OVERLOOK PLACE SUBDIVISION

APPLICATION NUMBER 24 DATE March 20, 2003
APPLICANT Overlook Place Subdivision
REQUEST Subdivision

DETAIL SITE PLAN

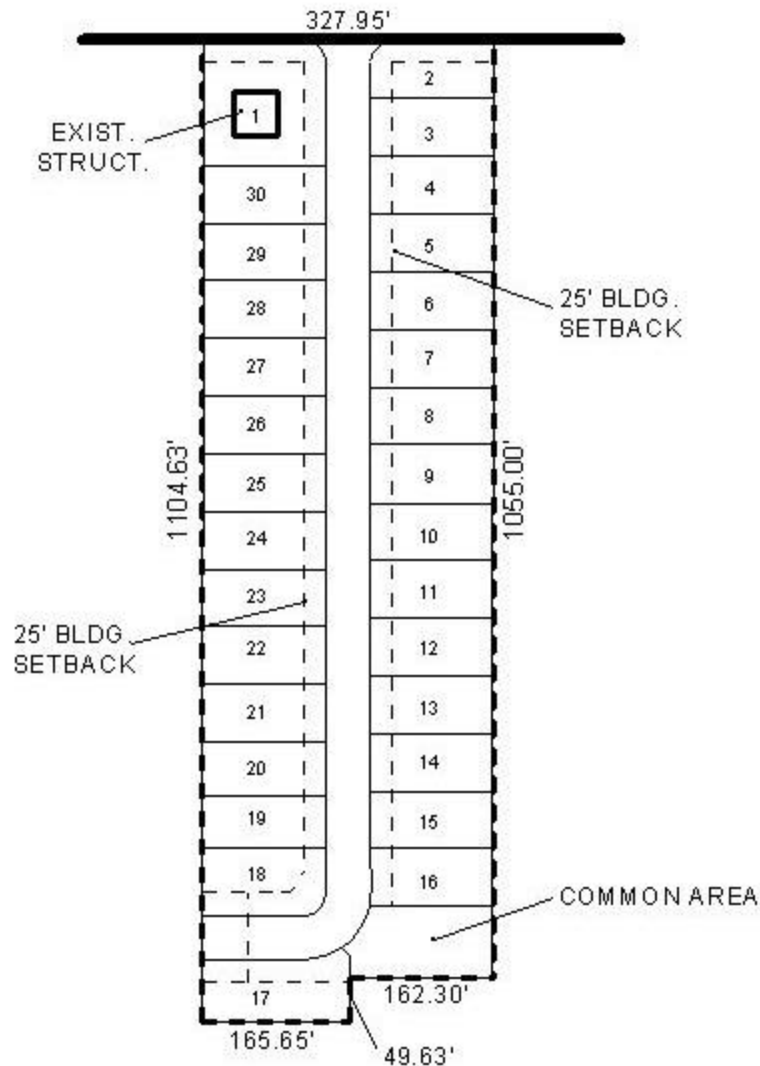
The Subdivision Regulations state that a closed end street (cul-de-sac) shall not be longer than 600'. As proposed, the cul-de-sac is approximately 1,000' in length; thus, a street stub to the West, between Lots 8-10, should be required. It should be noted that the large parcels to the East and West are undeveloped thus allowing for a continuation of the proposed street and street stub.

As proposed, Lots 1 and 2 would have frontage along Overlook Road and the new street; therefore, a note on the final plat stating the Lots 1 and 2 are denied direct access to Overlook Road, should be required.

The common area is labeled for detention and a note identifying this area as detention, as well as a note stating that the maintenance of the common area is the responsibility of the property owners, should be required on the final plat.

As proposed, the applicant is proposing a modified temporary turnaround for the proposed street to the West; however, a "cul-de-sac type" temporary turnaround with the appropriate radius, should be provided until the adjacent parcel is developed.

With modifications, the plat meets the minimum requirements of the Subdivision Regulations and is recommended for Tentative Approval subject to the following conditions: 1) the provision of a street stub to the West between Lots 8-10; 2) the placement of a note on the final plat stating that Lots 1 and 2 are denied direct access to Overlook Road; 3) the placement of a note on the final plat stating maintenance of all common areas is the responsibility of the property owners and labeled as detention; and 4) the provision of a "temporary" cul-de-sac until the property to the East is developed.
